TECHNICAL SERVICE BULLETIN

Technical Service Bulletin: 80-1087

Forest River is alerting you to an issue involving certain 2020 – R. POD - RPT195-80 travel trailer recreational vehicles. Please see the information below which describes the issue and provides you with details on the steps you should take to have your vehicle repaired.

R. POD - RPT195 A/C SHROUD – REMEDY INSTRUCTIONS

FIGURE 1

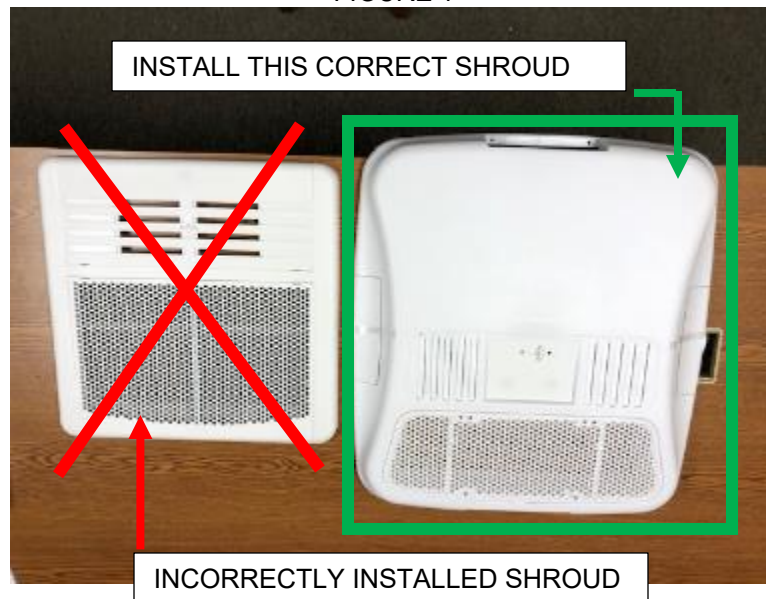
The manufacturing plant installed a ducted air conditioner shroud inside the vehicle while the vehicle manufactured with non-ducted air conditioning and requires the non-ducted air conditioning shroud.

STEP 1: REMOVE THE AIR CONDITIONER SHROUD DEPICTED IN FIGURE 1 AND PLATE (NOT PICTURED);

STEP 2: INSTALL THE KIT # 70A11314A (ORDERED FROM R. POD) PER THE INSTALLATION INSTRUCTIONS;

STEP 3: THERE IS NOT ANY WIRING THAT NEEDS TO CHANGE, TUCK ANY WIRING BACK INTO PLACE AND SECURE AS NEEDED;

STEP 4: DISCARD THE ORIGINAL AIR CONDITIONER SHROUD APPROPRIATELY.
